Cachuma Order WR-2019-0148 Term 27 Annual Compliance Report for Water Year 2020

**Cachuma Project, California
Interior Region 10 – California Great Basin**

Attachment A	Water Year 2020 Lake Cachuma Daily Operations
Attachment B	Water Year 2020 Annual Monitoring Report Pursuant to RPM 11 of the National Marine Fisheries Service 2000 Biological Opinion
Attachment C	Reclamation Response to Comments and Comment Letters on Draft Term 27 Annual Report

Figure 1. Flow Chart Depicting Interlinkages between Term 24 Studies

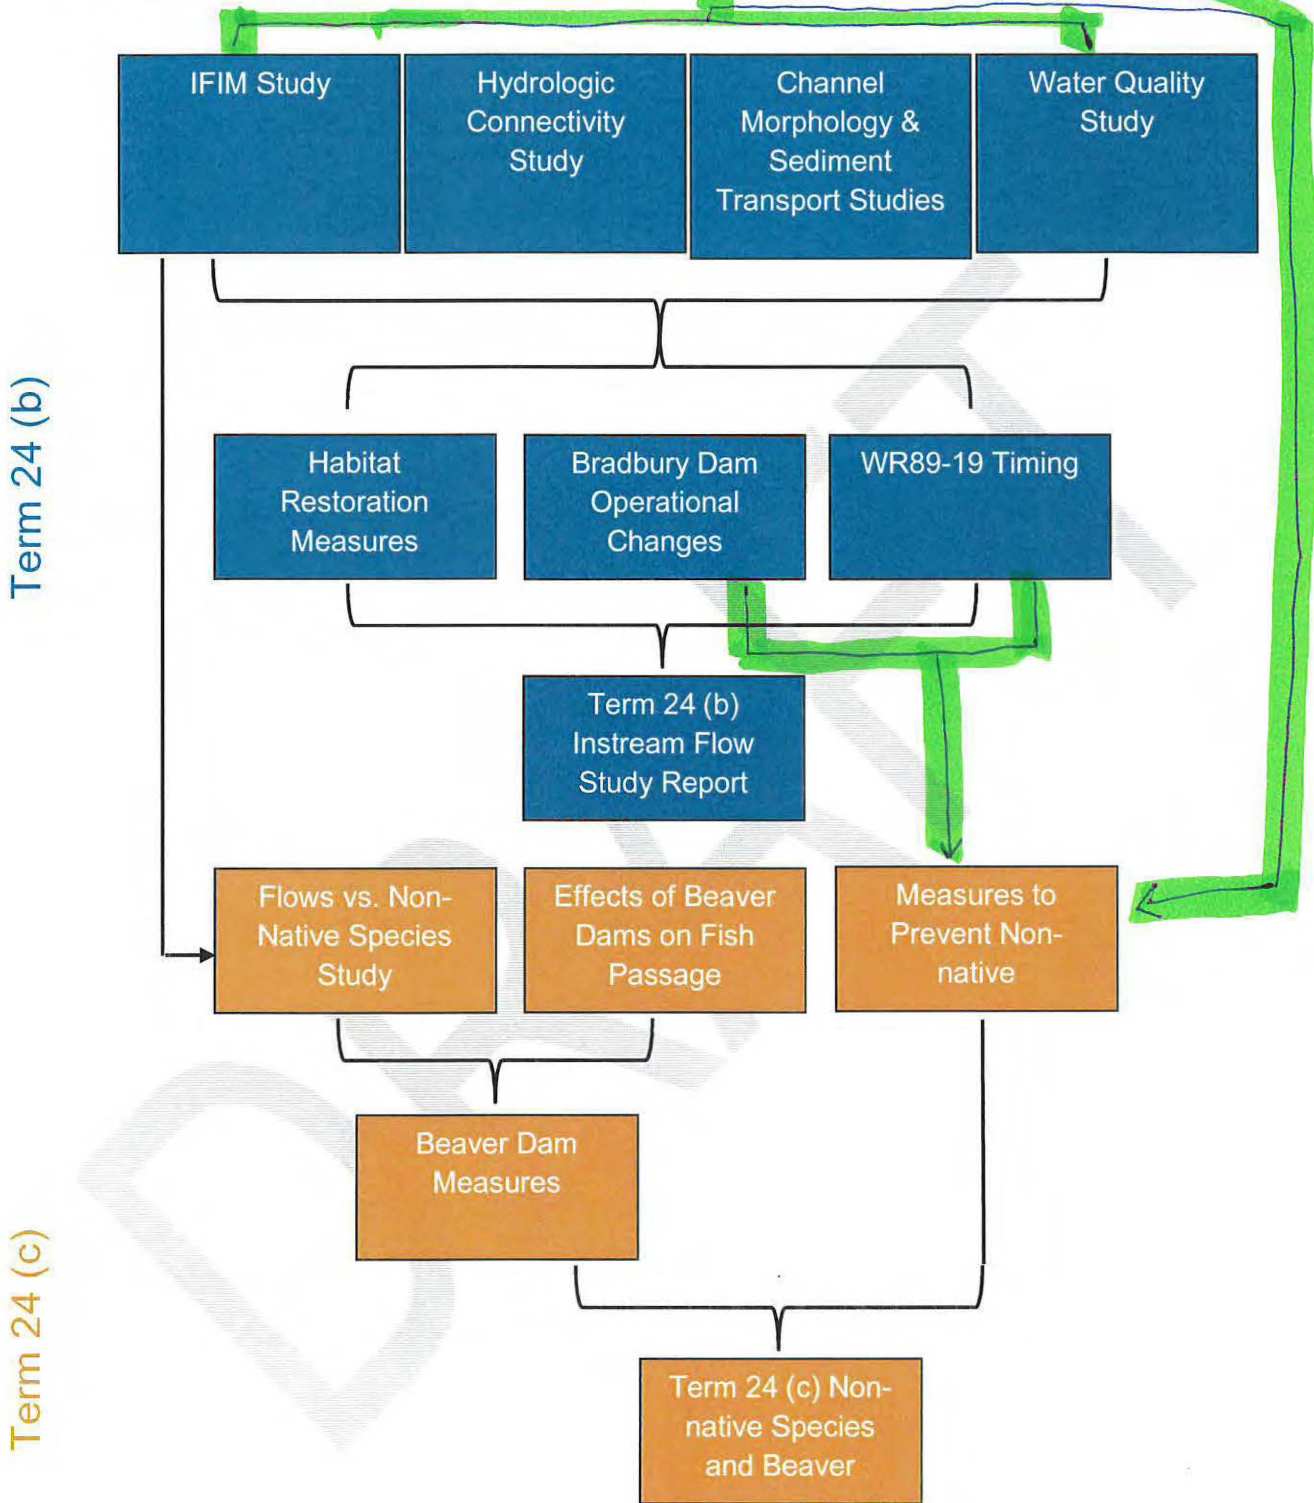
CDFW COMMENT #49: The flow chart should also show the interconnection of the top tier studies with the Term 24(c) measures to prevent non-natives (see Attachment C- CDFW recommendations on Figure 1. Flow Chart).
